Getting It Right  
-----

Steve Bracker  
March 6, 1994

I have read that part of Pauline's thesis dealing with triggering and data acquisition. It is replete with serious errors. Since a detailed understanding of these systems is not vital to carrying out the form factor analysis that is the essential subject matter of the thesis, there is no reason to believe that the physics in the thesis is in any way compromised. But if that be so, why is the Trigger and Data Acquisition section in the thesis at all? Given that it is present, why wasn't it reviewed by someone familiar with triggering and data acquisition before the thesis was published?

Figure 3.2. Flow of data from the digitizers through the data acquisition system.

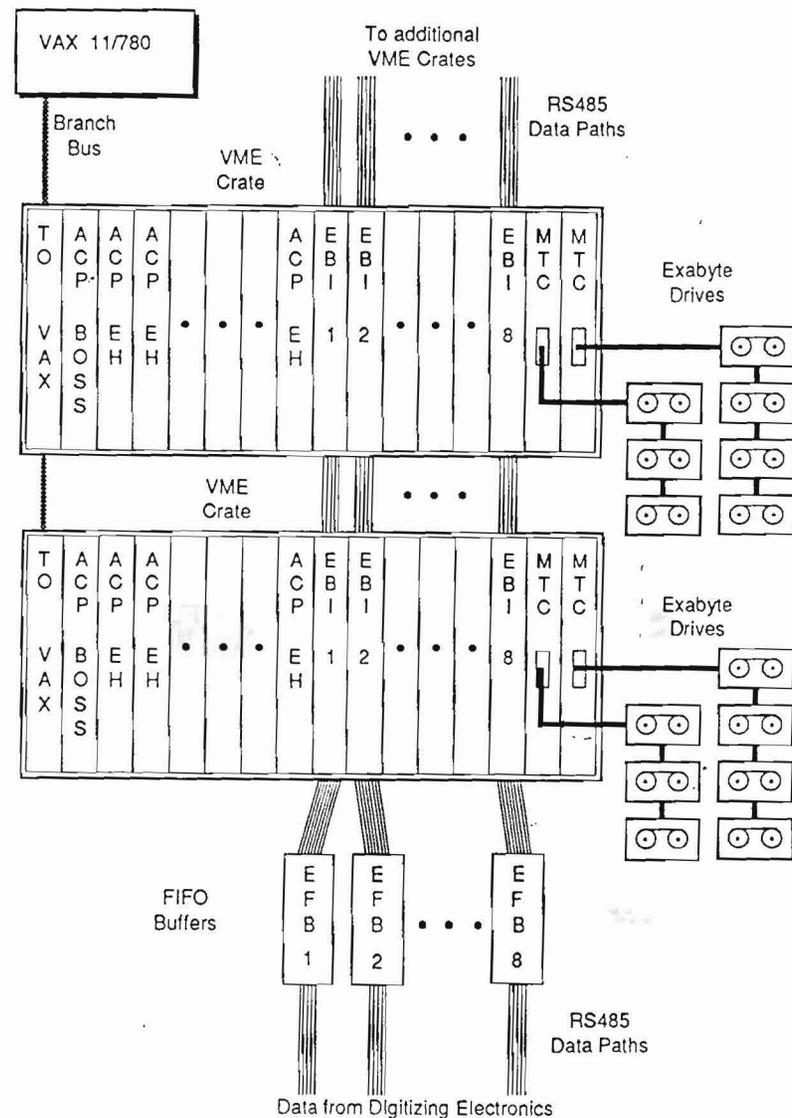
Referring to 3.3.2: The ACP processors are modules distinct from the Event Buffer Interfaces, which are VME cards designed and built at Fermilab by Sten Hansen, myself, and several students. Figure 3.2, a system drawing similar to the one I prepared for my DA talks, makes that clear.
